SUBJECT: ISSUANCE OF AMENDMENTS - DONALD C. COOK NUCLEAR PLANT, UNITS 1 AND 2, RE: FUEL ROD ZIRLO CLADDING AND INTEGRAL FUEL BURNABLE ABSORBER REQUIREMENTS (TAC NOS. MA7041 AND MA7042)

The U.S. Nuclear Regulatory Commission has issued the enclosed Amendment No. 239 to Facility Operating License No. DPR-58 and Amendment No. 220 to Facility Operating License No. DPR-74 for the Donald C. Cook Nuclear Plant, Units 1 and 2. The amendments consist of changes to the Technical Specifications in response to your application dated November 3, 1999.

ATTACHMENT TO LICENSE AMENDMENT NO. 239

ATTACHMENT TO LICENSE AMENDMENT NO. 220

Figure 5.6-4: New Fuel Storage Rack Integral Fuel Burnable Absorber (IFBA) Requirements

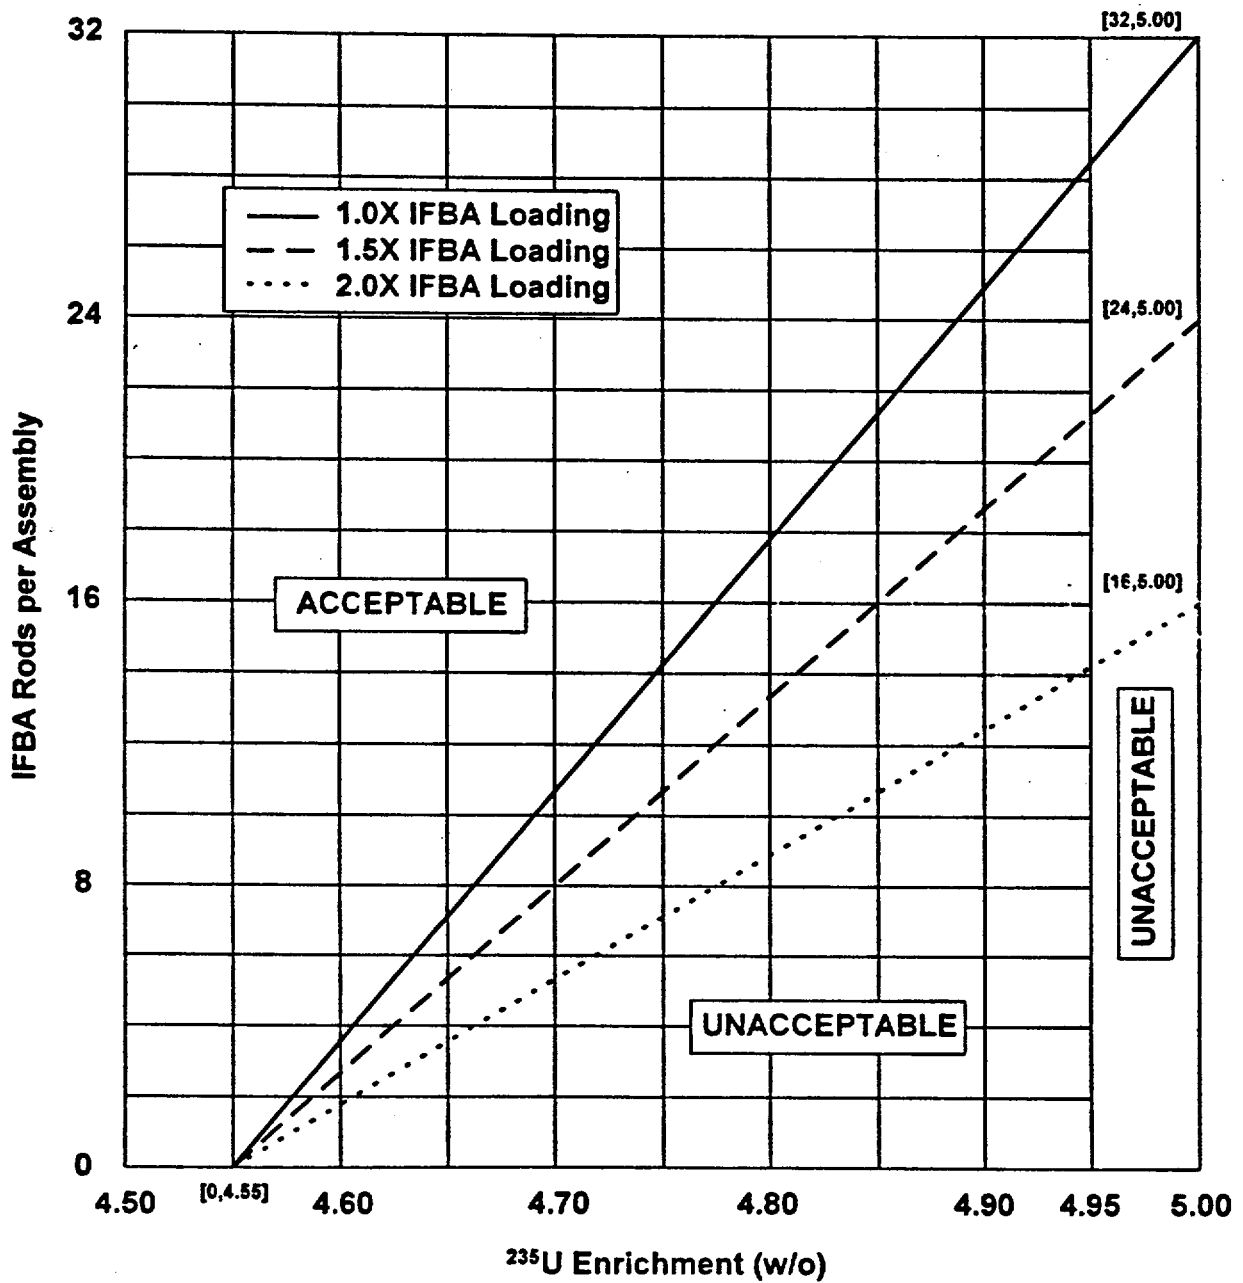
- a. Westinghouse fuel assemblies having either a maximum enrichment of 4.55 weight % U-235, or an enrichment between 4.55 and 4.95 weight % U-235 with greater than or equal to the minimum number of integral fuel burnable absorber pins as shown on Figure 5.6-4 (interpolation of the Boron-10 loading between 1.0X and 1.5X and between 1.5X and 2.0X is acceptable);
- b.  $k_{\text{eff}} \leq 0.95$  if fully flooded with unborated water, which includes an allowance for uncertainties as described in Section 9.7 of the UFSAR;
- c.  $k_{\text{eff}} \leq 0.98$  if moderated by aqueous foam, which includes an allowance for uncertainties as described in Section 9.7 of the UFSAR; and
- d. A nominal 21 inch center to center distance between fuel assemblies placed in the storage racks.

The licensee proposes to revise TS 5.6.2.a and add a new TS Figure 5.6-4, "New Fuel Storage Rack Integral Fuel Burnable Absorber (IFBA) Requirements," to specify maximum enrichments and IFBA requirements for Westinghouse fuel in the new fuel storage racks. Specifically, TS 5.6.2.a is proposed to state that the new fuel storage racks are designed and shall be maintained with "Westinghouse fuel assemblies having either a maximum enrichment of 4.55 weight % U-235, or an enrichment between 4.55 and 4.95 weight % U-235 with greater than or equal to the minimum number of integral fuel burnable absorber pins as shown on Figure 5.6-4 (interpolation of the Boron-10 loading between 1.0X and 1.5X and between 1.5X and 2.0X is acceptable)." The new TS Figure 5.6-4 specifically covers IFBA requirements between 4.55 and 4.95 weight % U-235. The licensee proposes to delete the footnote for TS Table 5.6-1 since it is superseded by the proposed change to TS 5.6.2.a.

New TS Figure 5.6-4 is based on the reactivity equivalencing calculational method described in CDB-95-175, which was previously reviewed and approved by the NRC for Amendment Nos. 213 and 198. Use of this method ensures the required reactivity margin is maintained for storage of Westinghouse fuel assemblies in the new fuel storage racks. Therefore, the staff considers the proposed method for determining IFBA requirements and resulting TS changes acceptable.

Figure 5.6-4: New Fuel Storage Rack Integral Fuel Burnable Absorber (IFBA) Requirements

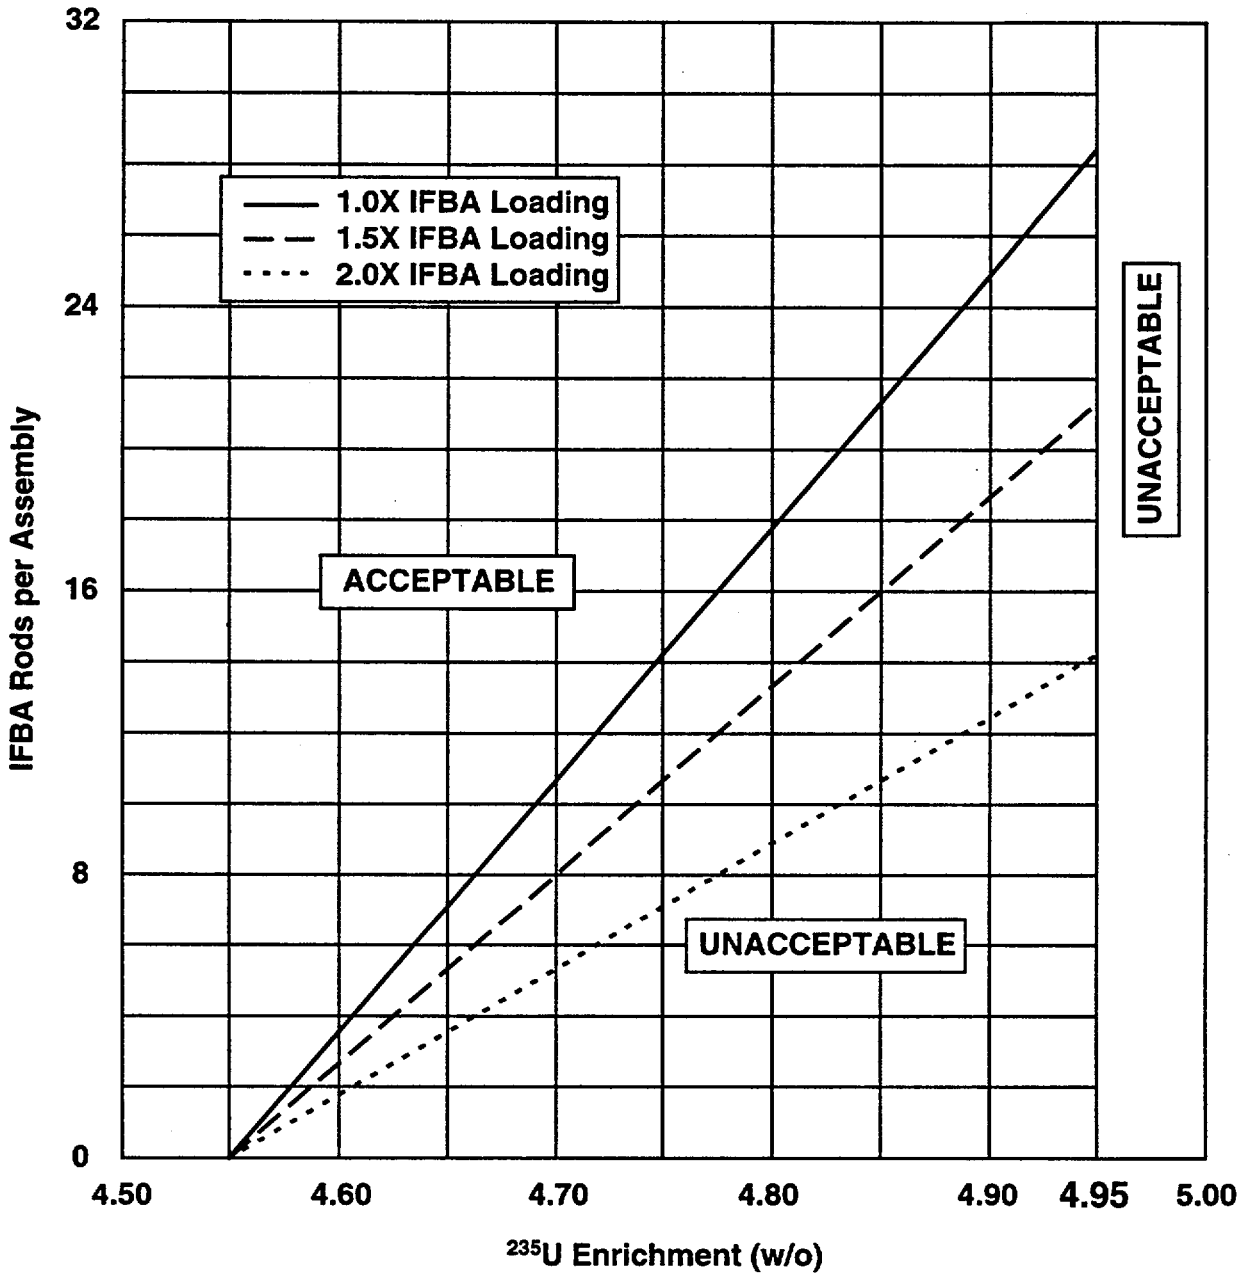
- a. Fuel assemblies having either a maximum enrichment of 4.55 weight % U-235, or an enrichment between 4.55 and 4.95 weight % U-235 with the minimum number of integral fuel burnable absorber pins as shown on Figure 5.6-4 (interpolation of the Boron-10 loading between 1.0X and 1.5X and between 1.5X and 2.0X is acceptable);
- b.  $k_{\text{eff}} \leq 0.95$  if fully flooded with unborated water, which includes an allowance for uncertainties as described in Section 9.7 of the UFSAR;
- c.  $k_{\text{eff}} \leq 0.98$  if moderated by aqueous foam, which includes an allowance for uncertainties as described in Section 9.7 of the UFSAR; and
- d. A nominal 21 inch center to center distance between fuel assemblies placed in the storage racks.
